RANCHO SANTIAGO COMMUNITY COLLEGE DISTRICT

ADDENDUM NO. 1

Bid #1413 BR Signage and Wayfinding
at
Santiago Canyon College

January 18, 2022

3 ALUMINUM SIGN SECTION
SCALE: 1-1/2" = 1'-0"

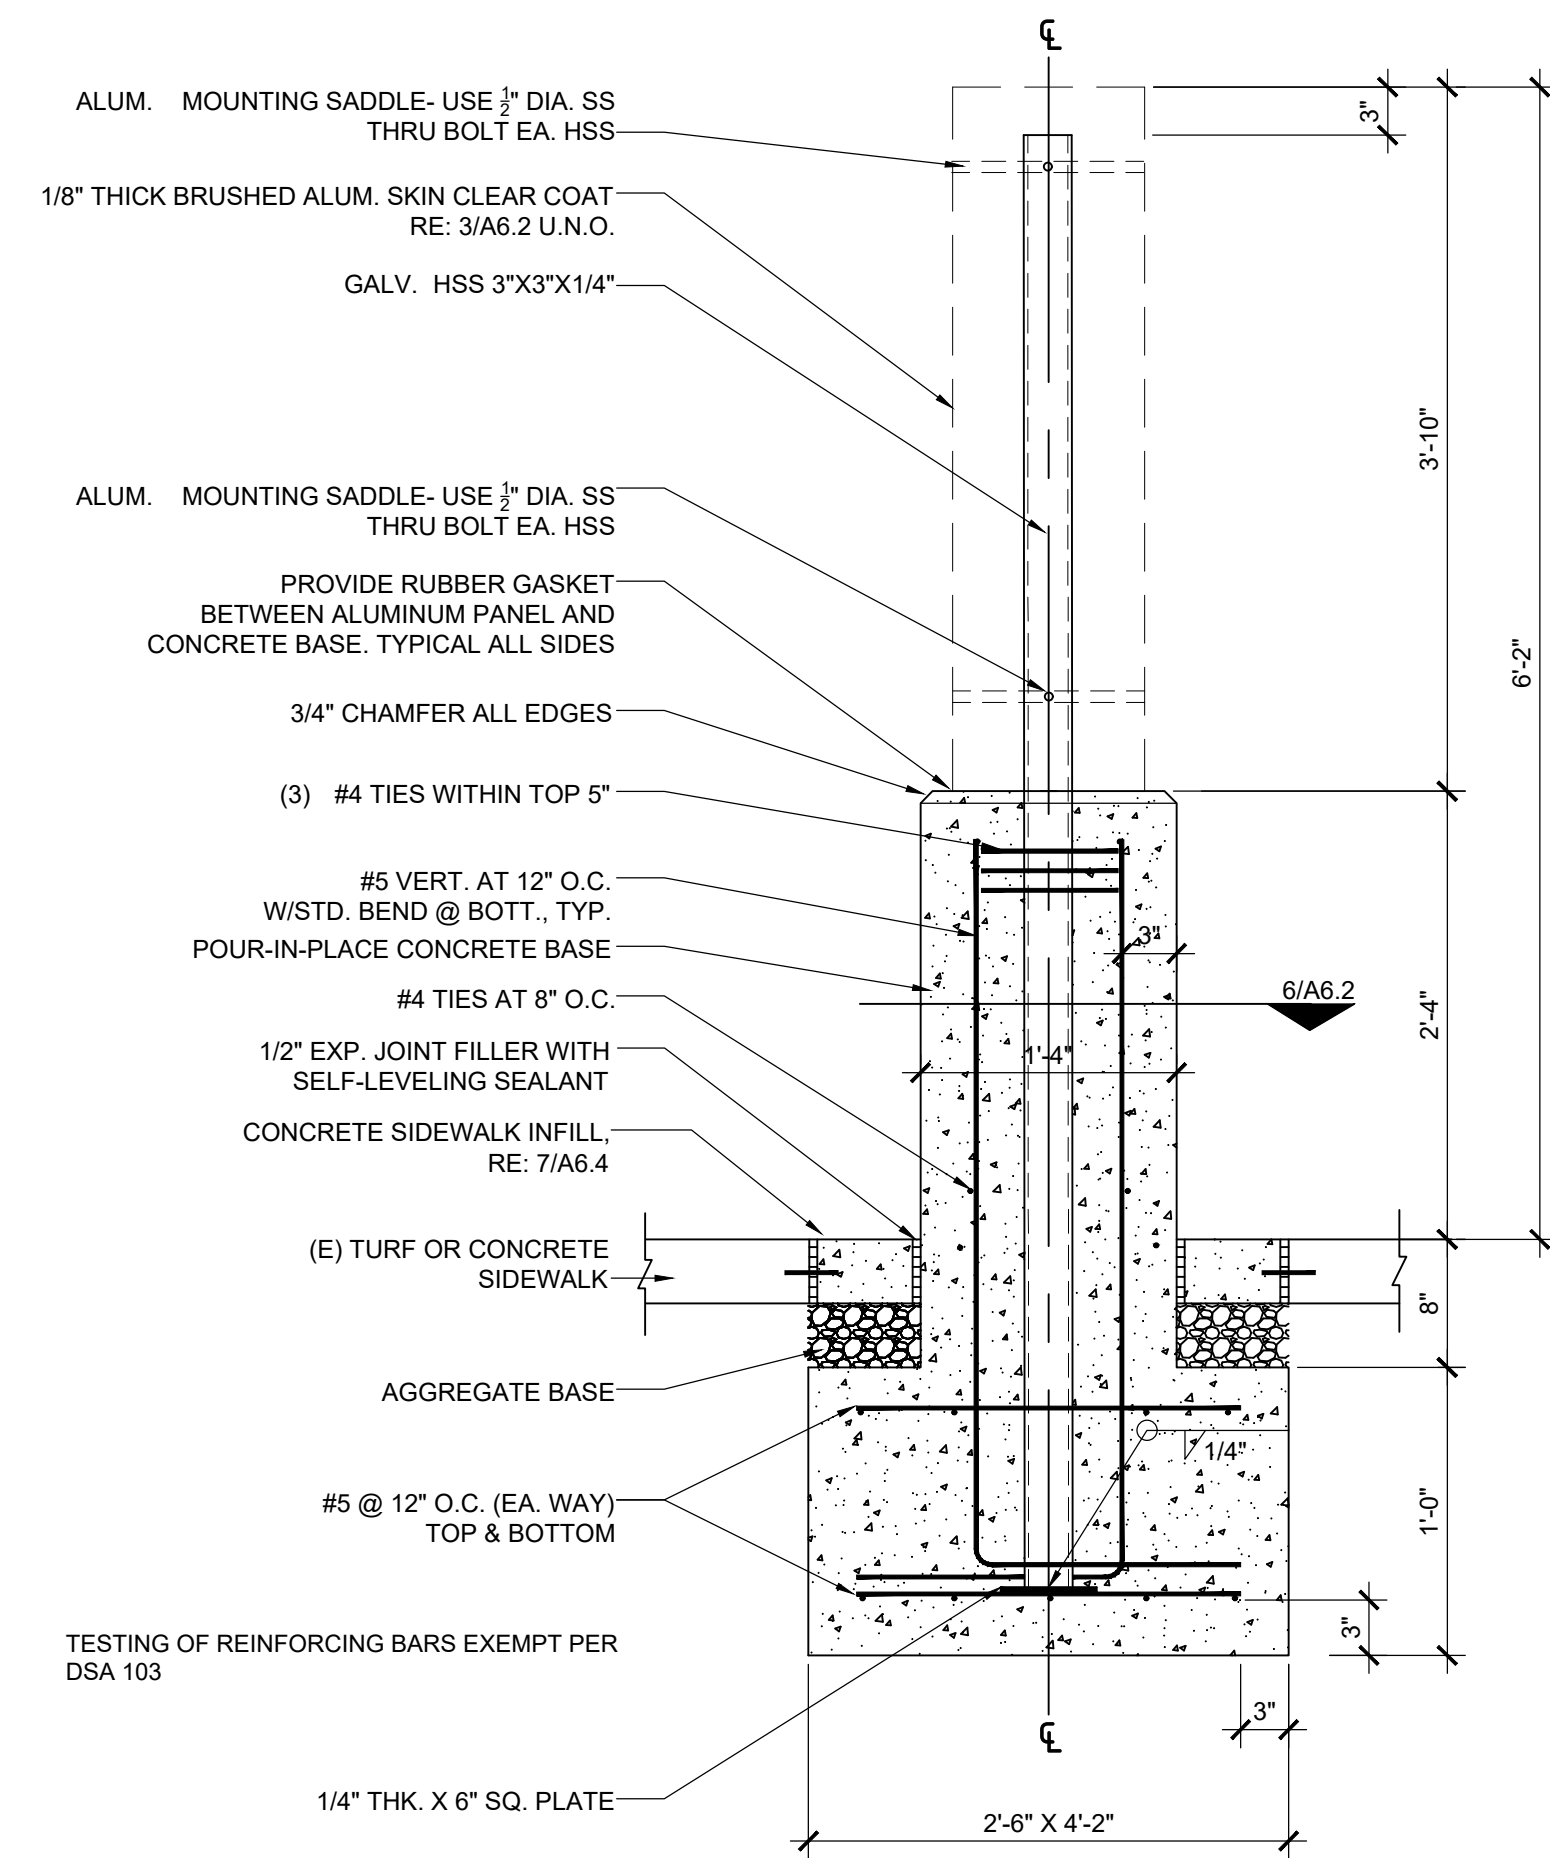
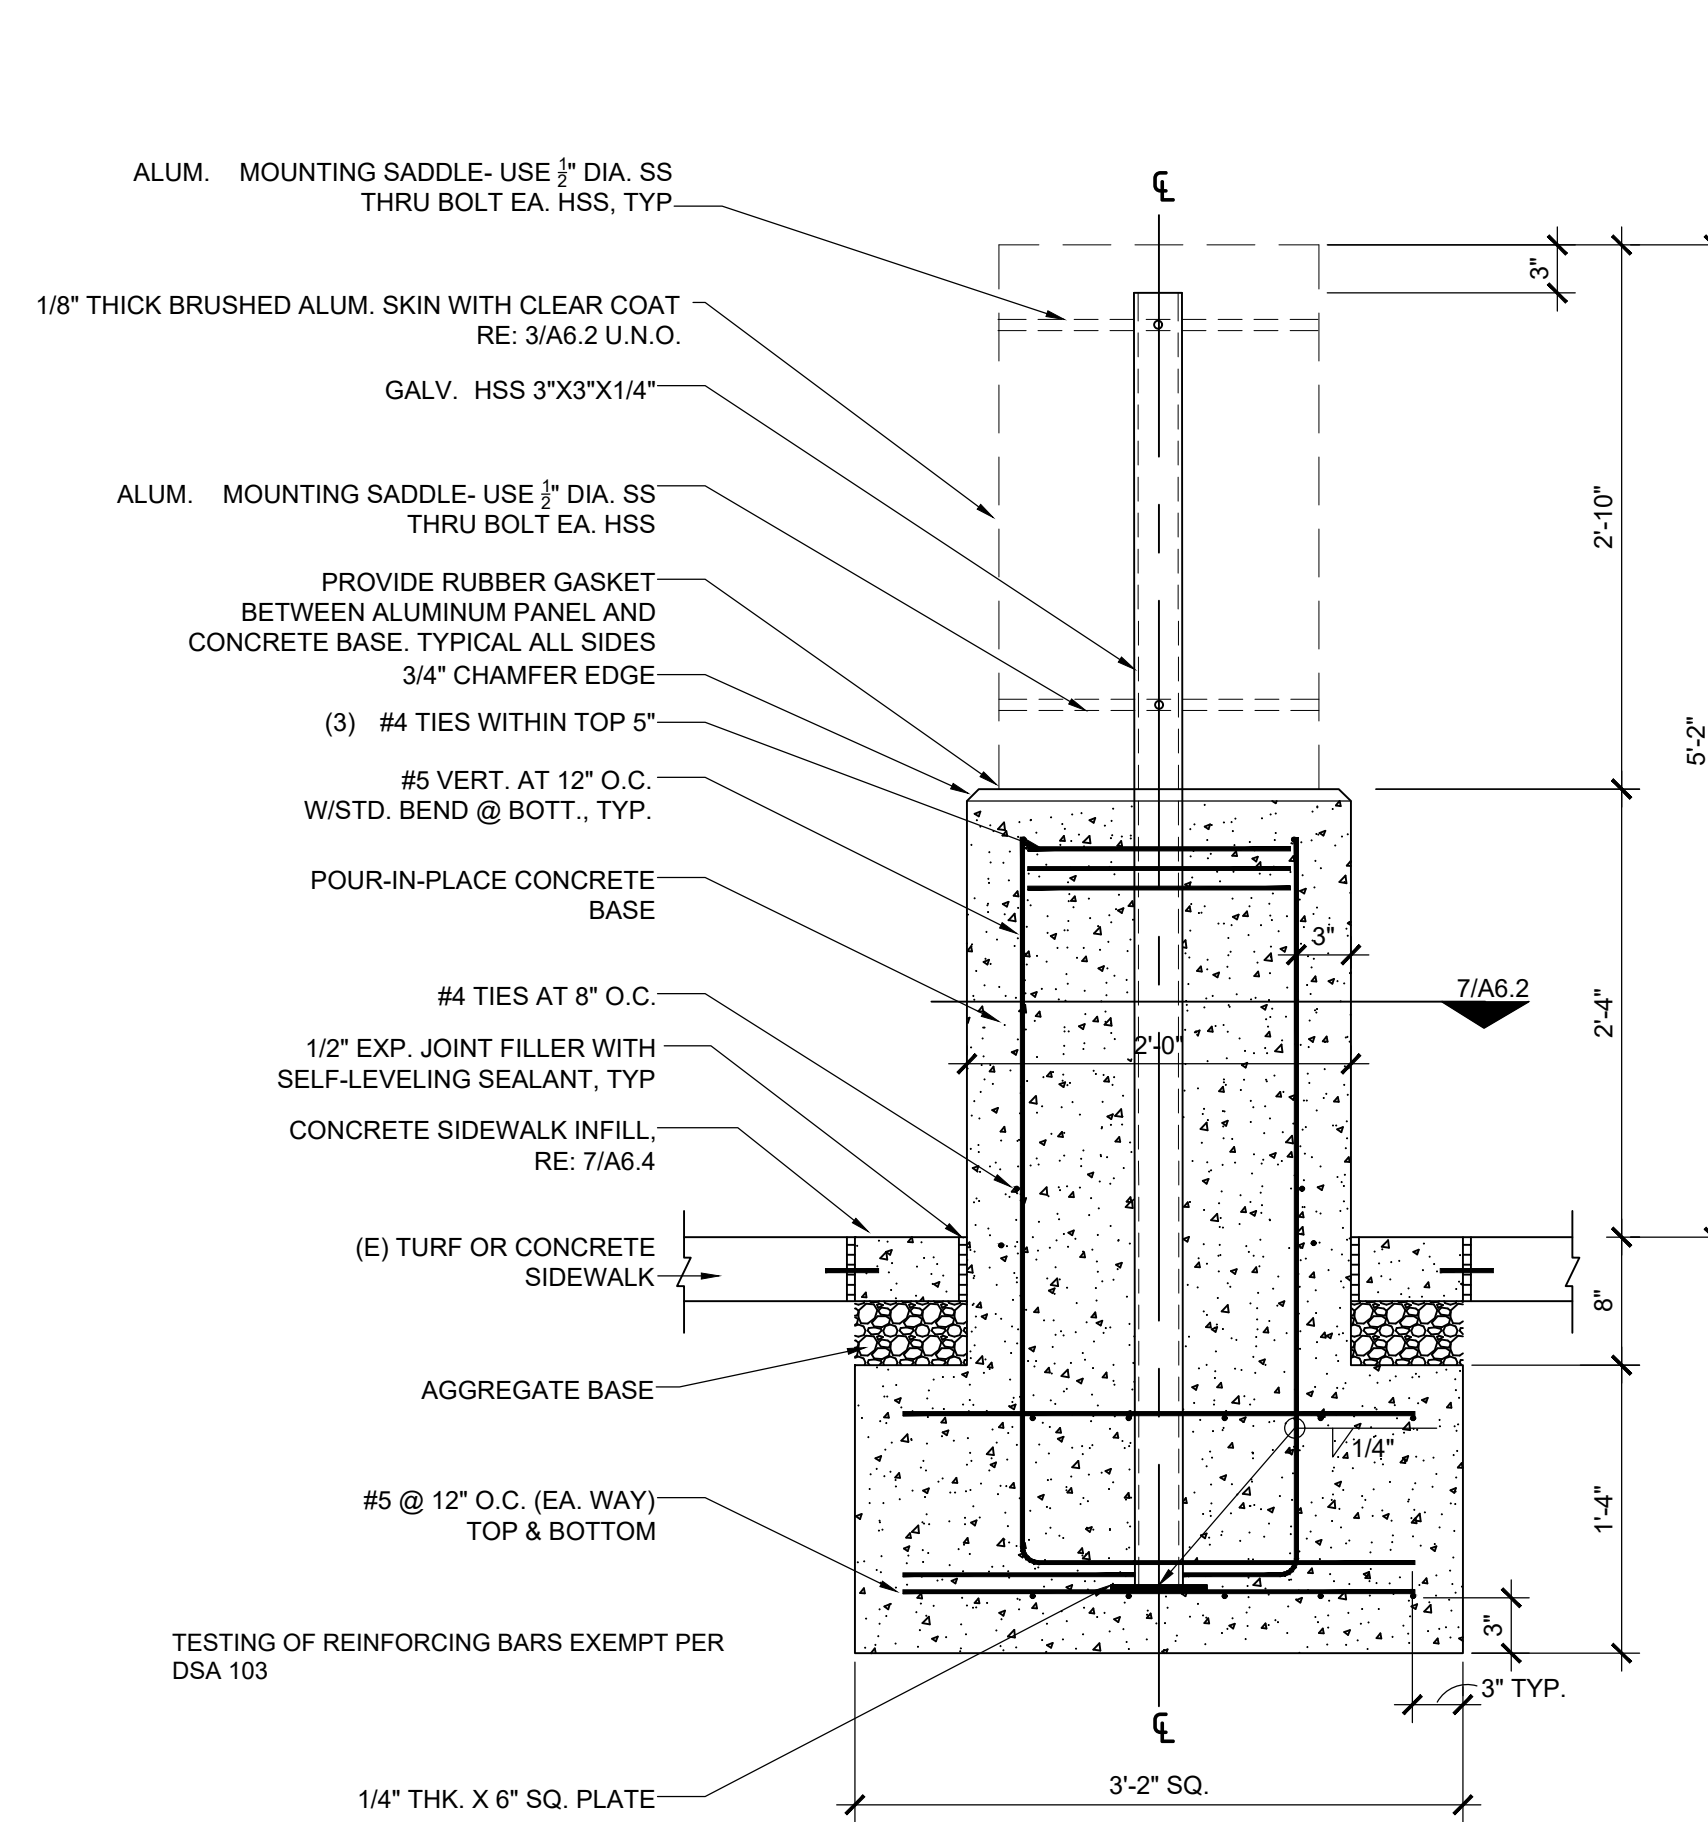
Refer to attached Drawings A6.2, Sign Details, General Notes. Revise General Note No. 1 as follows:

1. Contractor to repair existing hardscape, landscaping and irrigation at new construction, field verify.
 - A. PVC pipe and fittings to match existing.
 - B. Reroute with 45-degree elbows in lieu of 90-degree elbows.
 - C. Adjust adjacent existing sprinkler head positioning where spray is not spraying monuments.
 - D. Sprinkler heads to match existing and approved by District representative.
